SUBJECT: Rapid Response Transmittal Service Action #04-029
Structural Dust Cover Bolt May Contact Oil Pan

INVOLVED VEHICLES: 2005 (WK) Grand Cherokee

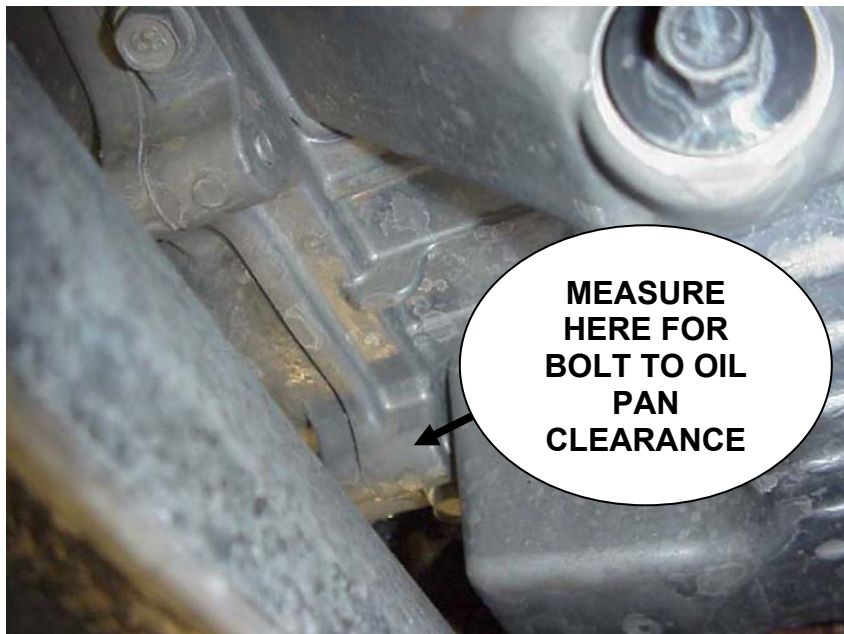
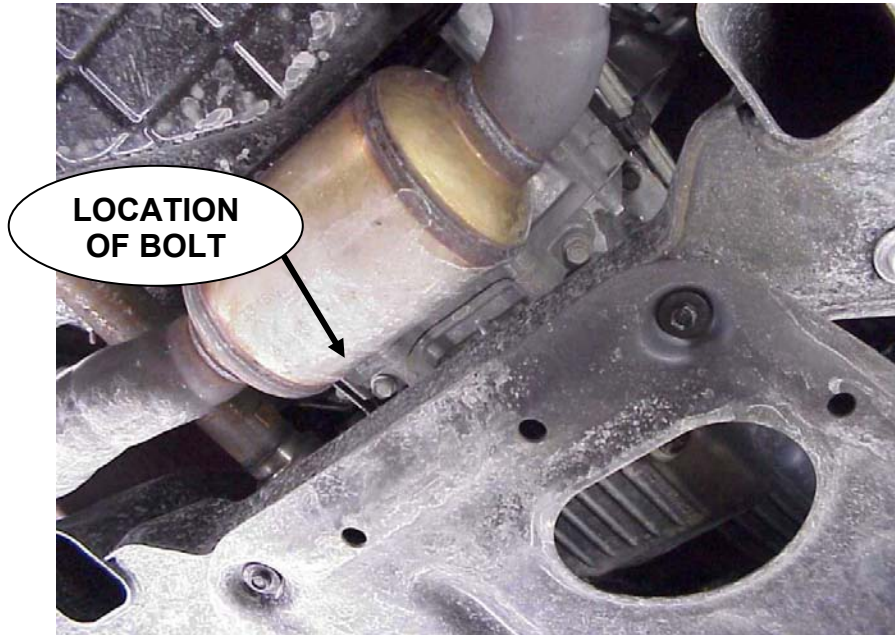
1. Raise the vehicle on a suitable lift.
2. Locate the suspect transmission inspection cover bolt at the back of the engine oil pan on the left (driver) side of the vehicle.

3. Inspect the head of the suspect bolt. If the number on the head of the suspect bolt is a “9.8”, then there should be no interference issue. Verify clearance, lower vehicle, and return to customer.

4. If the number on the head of the suspect bolt is a “10.9”, then there may be an interference issue between the end of the bolt and the engine oil pan.

1. Replace the structural dust cover bolt. Tighten to 54 Nm (40 ft. lbs.).
2. Replace the engine oil pan and the structural dust cover bolt. Refer to the Technical Information (9 – Engine / Lubrication / Oil Pan / Removal / Oil Pan) on TechCONNECT for detailed removal and installation procedures.
